addendum

No.	02	**Project:**	WCFPD Station 1
Date:	September 19, 2025	**Project No:**	025-2125

2 FIRST FLOOR PLAN - MECHANICAL DUCTWORK
M200 1/8" = 1'-0"

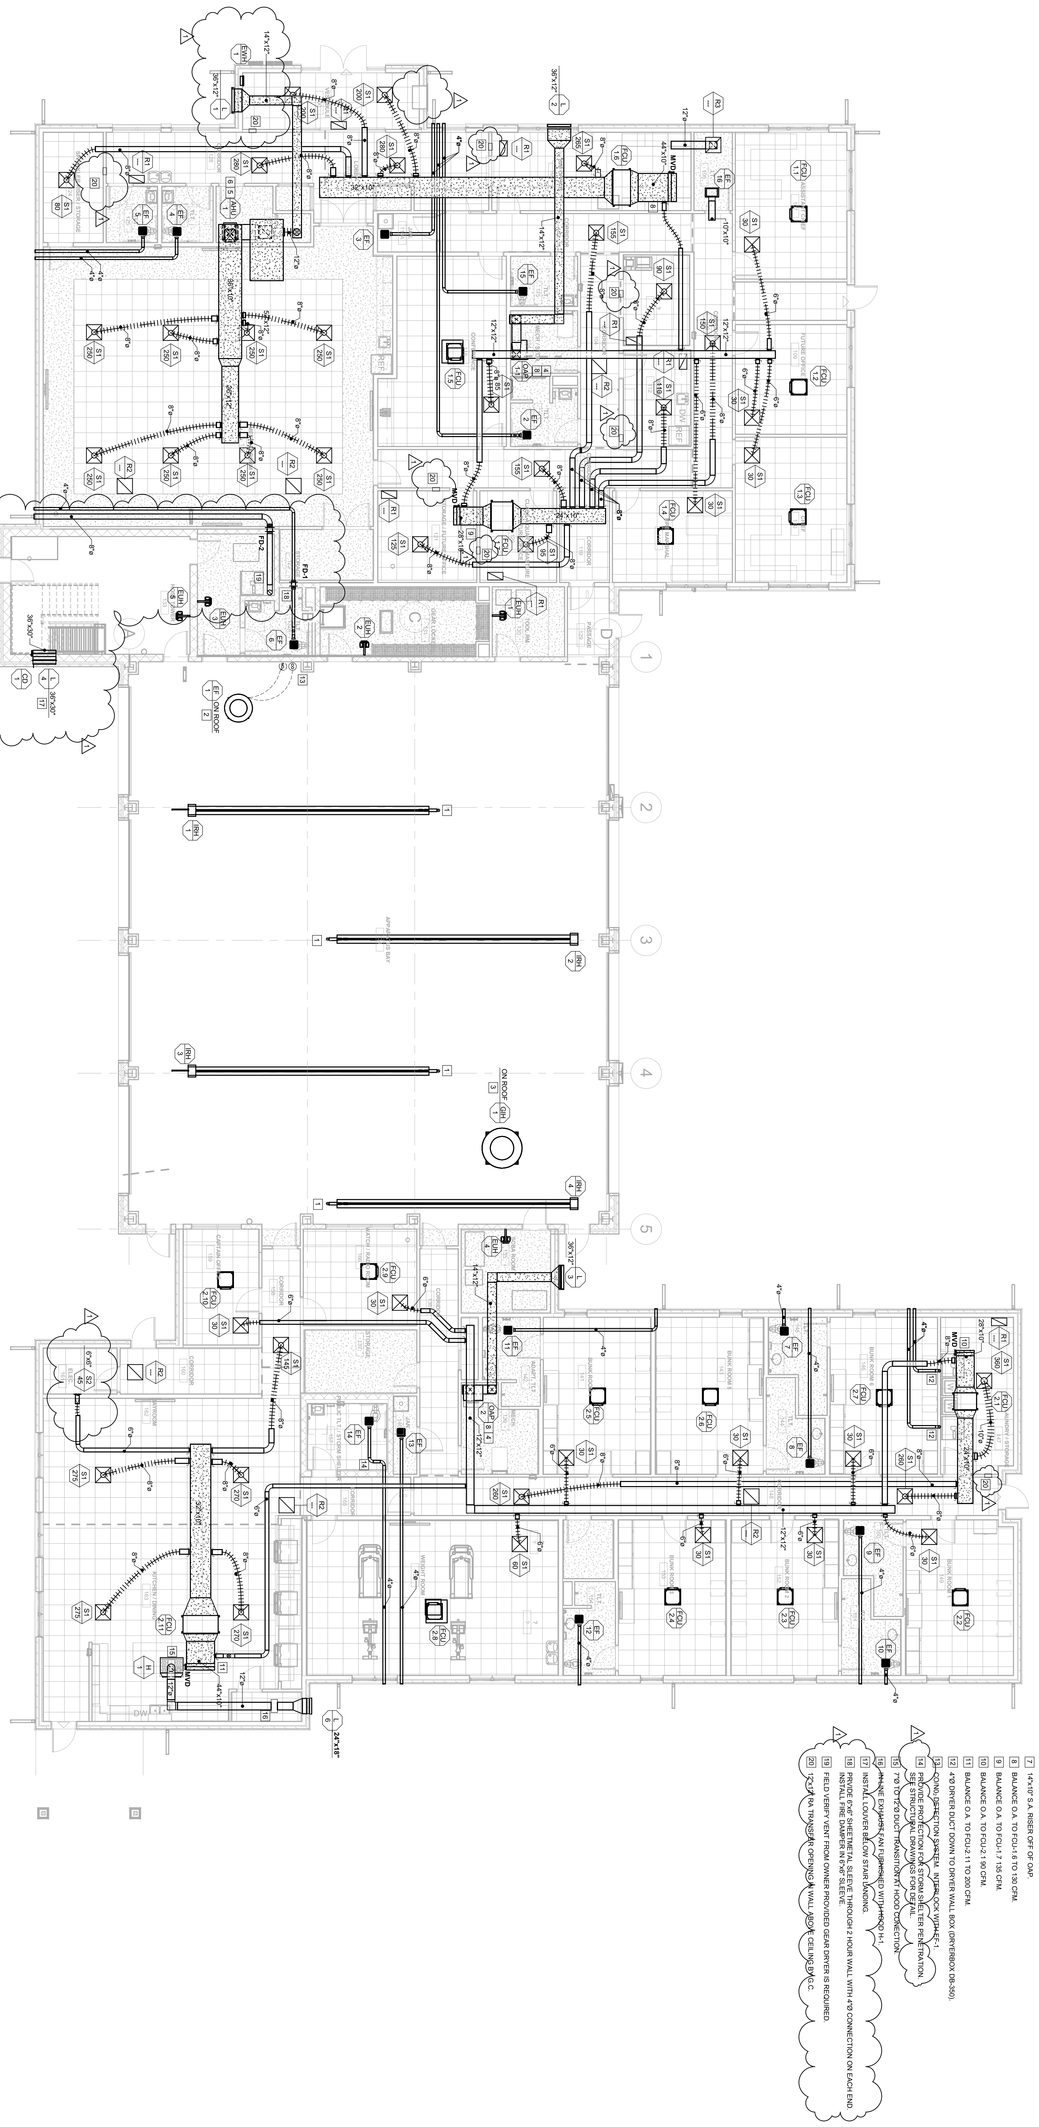
38) Sheet M200 – FIRST FLOOR PLAN – MECHANICAL
    a. NOTED return air transfer openings by G.C. in full height partitions.
    b. ADD fire dampers FD-1 and FD-2.

c. ADJUSTED location of louver L-4 in Hose Tower 133.
    d. REVISED air device type for Elec 161.
39) Sheet M201 – ROOF PLAN – MECHANICAL

1 ROOF PLAN - MECHANICAL
M201 1/8" = 1'-0"

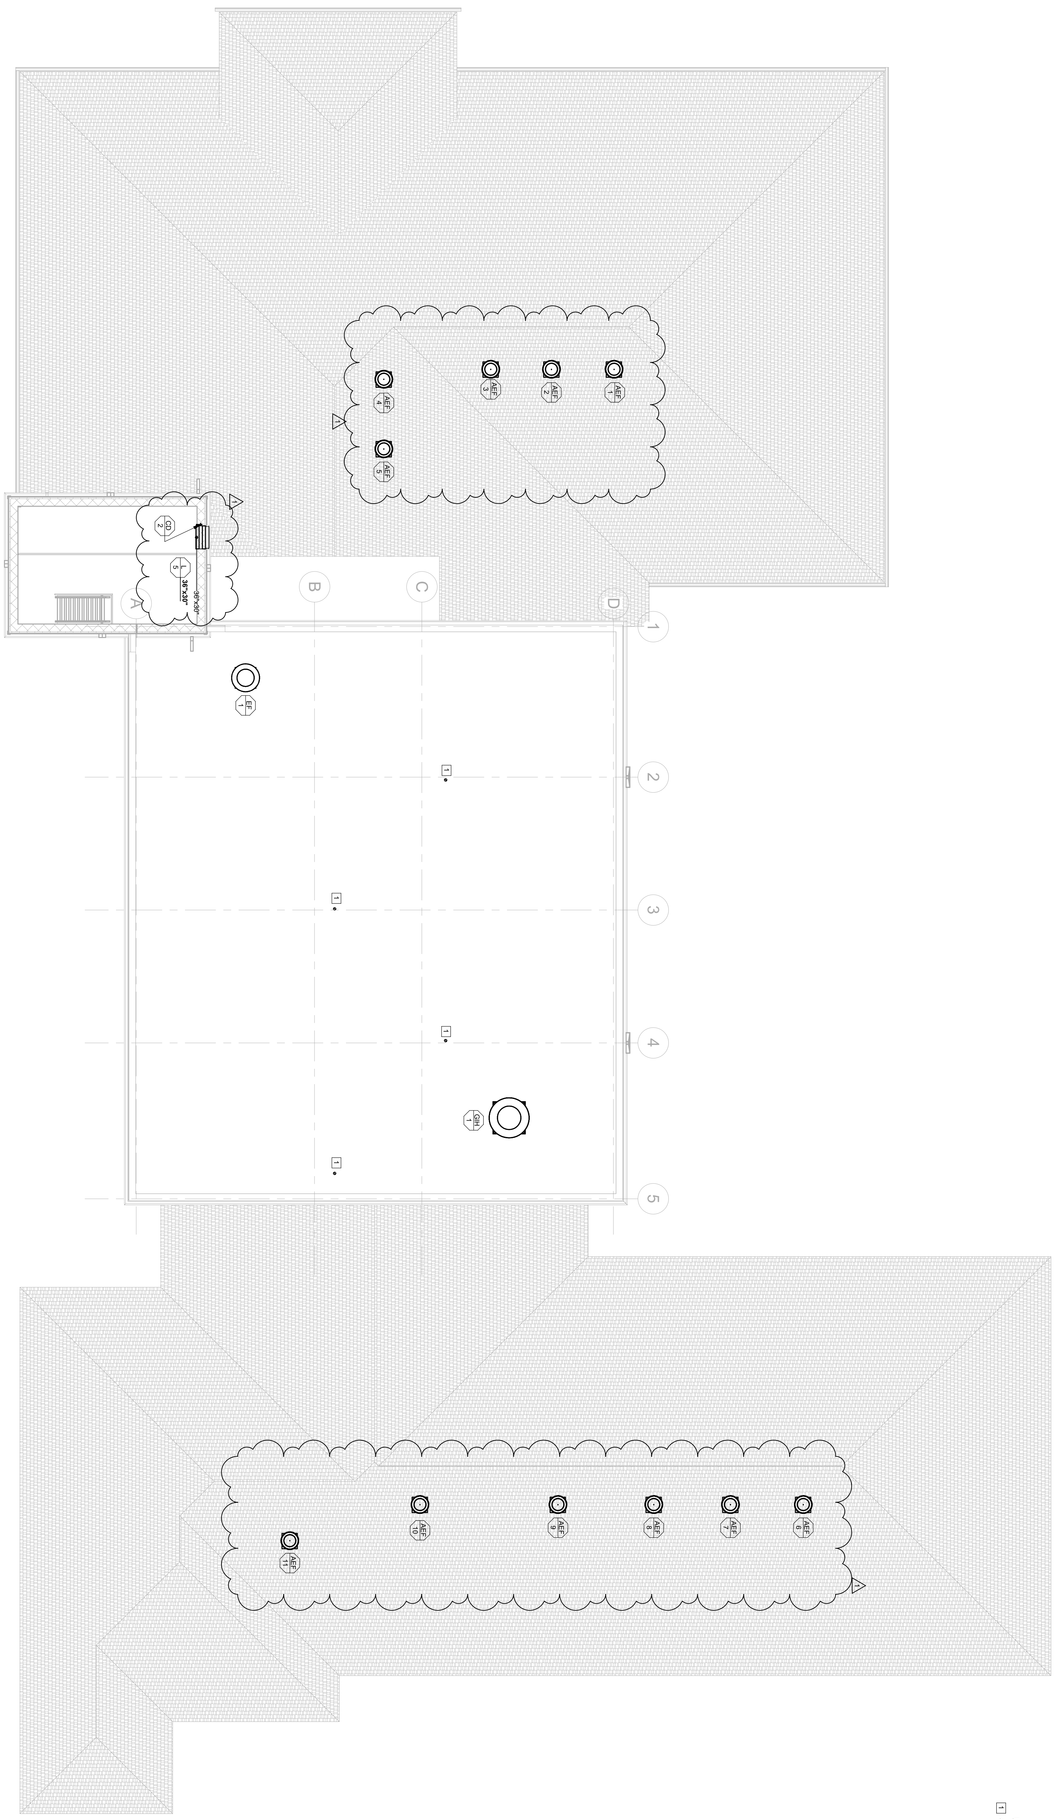
a. ADD attic ventilation fans.
b. ADJUSTED location of louver L-5 in Hose Tower 133.

3 FIRST FLOOR PLAN - MECHANICAL PIPING
M300 1/8" = 1'-0"

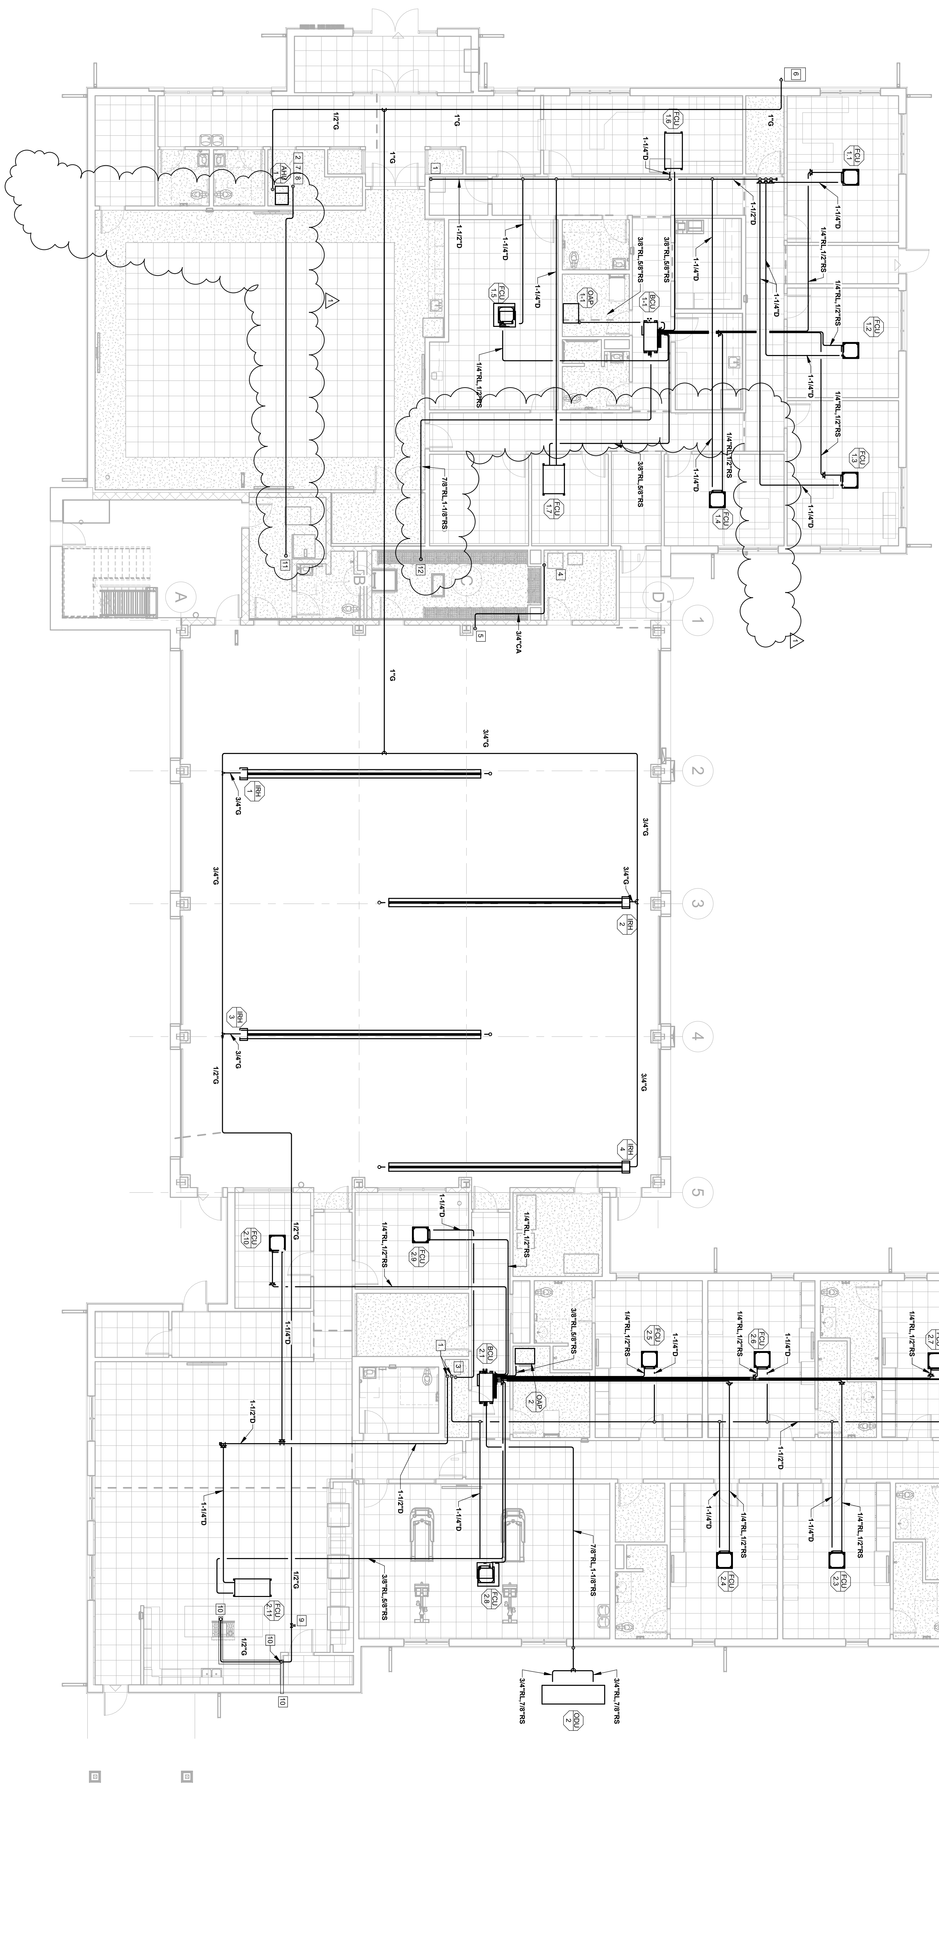
40) Sheet M300 – FIRST FLOOR PLAN – MECHANICAL PIPING
    a. RELOCATED ODU-1 from grade to roof.
    b. RELOCATED CU-1 from grade to roof.
41) Sheet M301 – ROOF PLAN – MECHANICAL PIPING

FLOOR PLAN - POWER & SYSTEMS

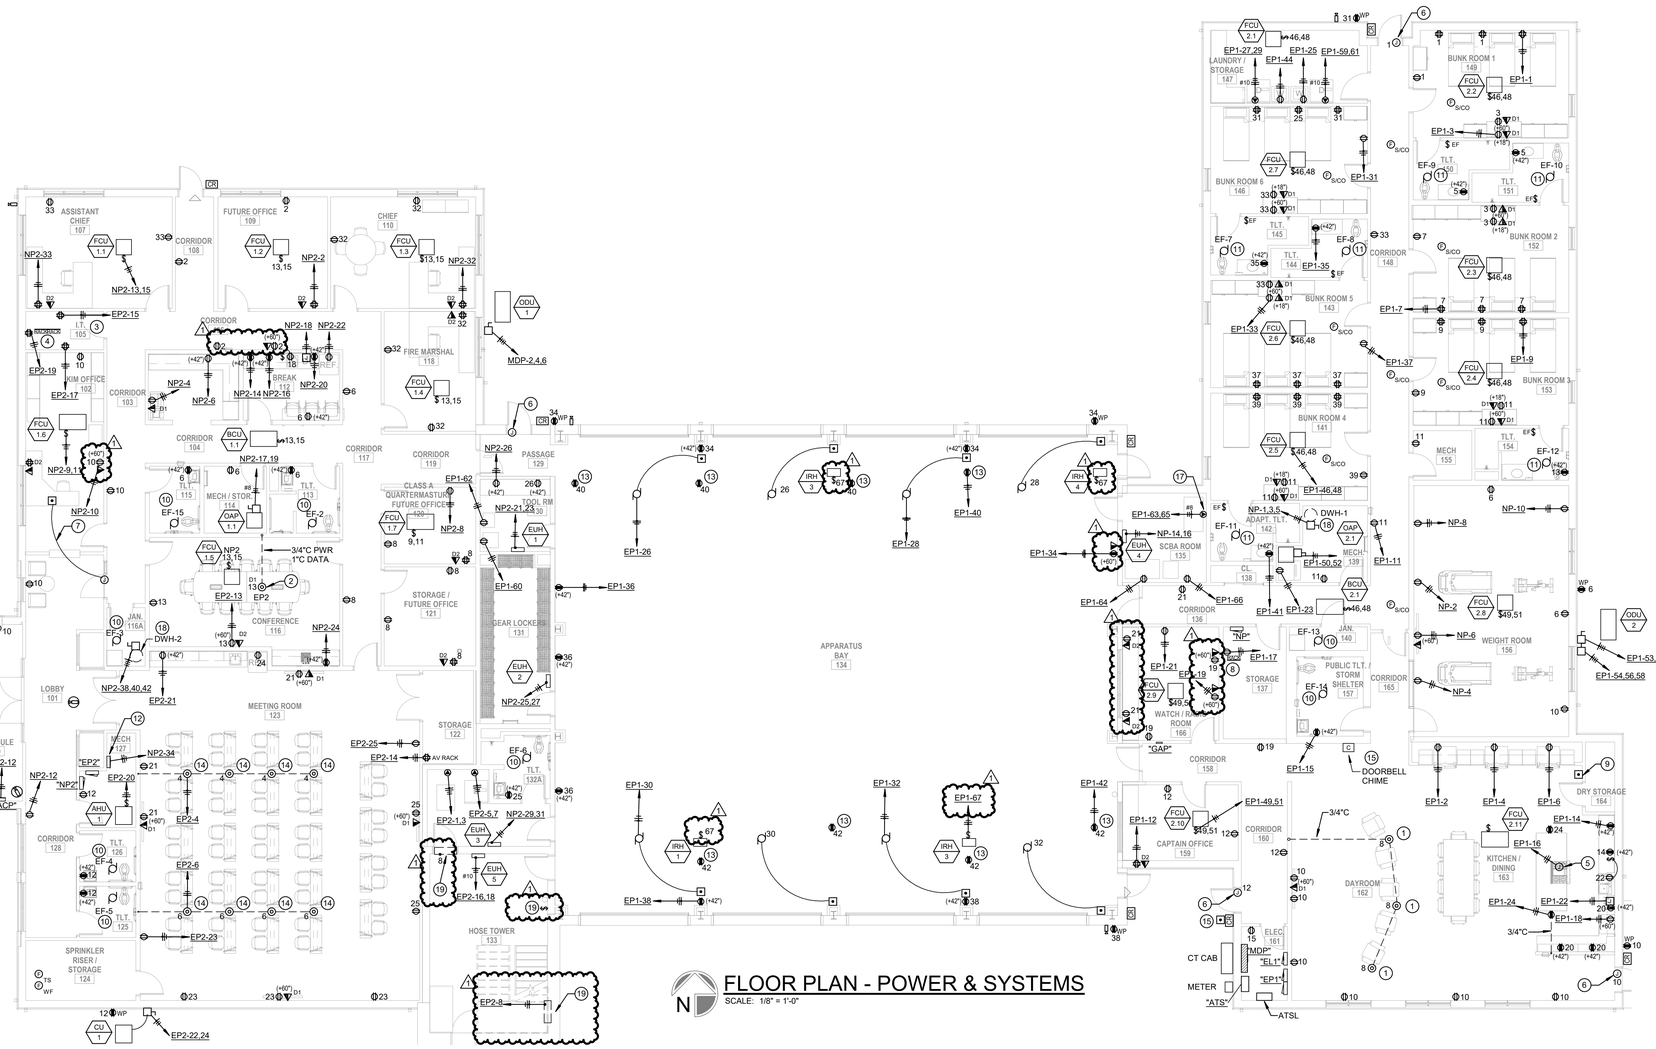
45) Sheet E201 – FLOOR PLAN
    a. ADD power to storm shelter louvers.
    b. ADD power to various TV locations.
    c. REVISE heaters in garage to be powered from EM panel.

d. REVISE Design Build Scope to be Low Voltage Scope and revised scope of work.
46) Sheet E301 – CEILING PLAN
    a. RELOCATED ceiling fans in app bay and deleted one.

CEILING PLAN - LIGHTING

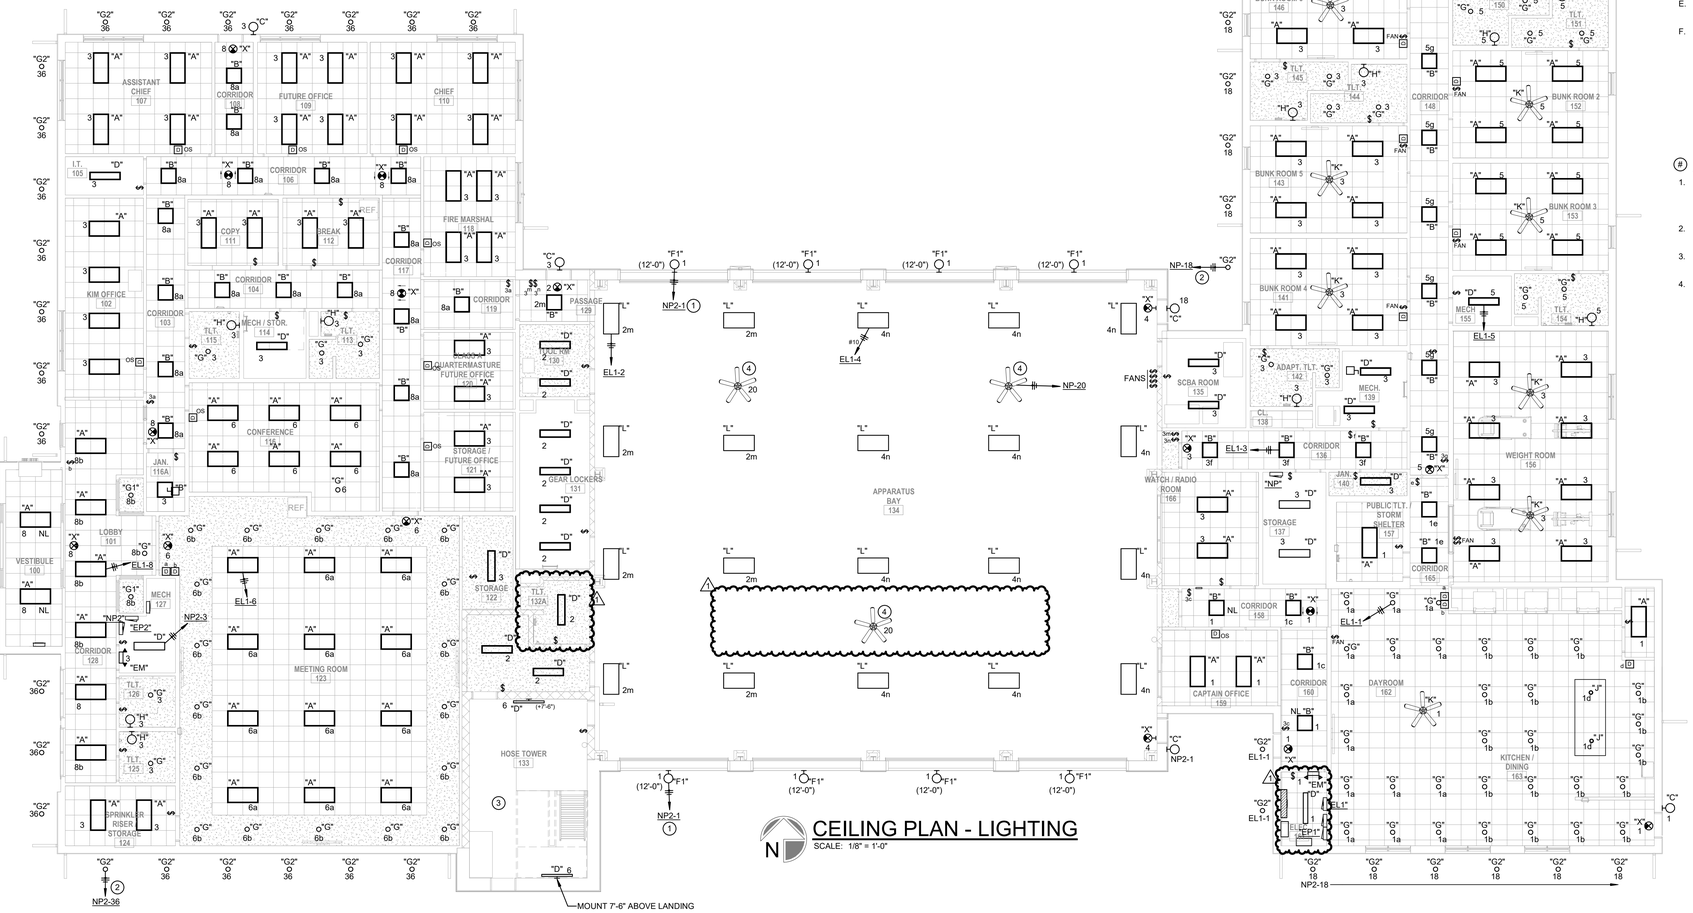
b. REVISED lighting fixtures in storm shelter and electrical room.
47) Sheet E500 – ELECTRICAL SCHEDULES
    a. REVISED electrical schedules accordingly.
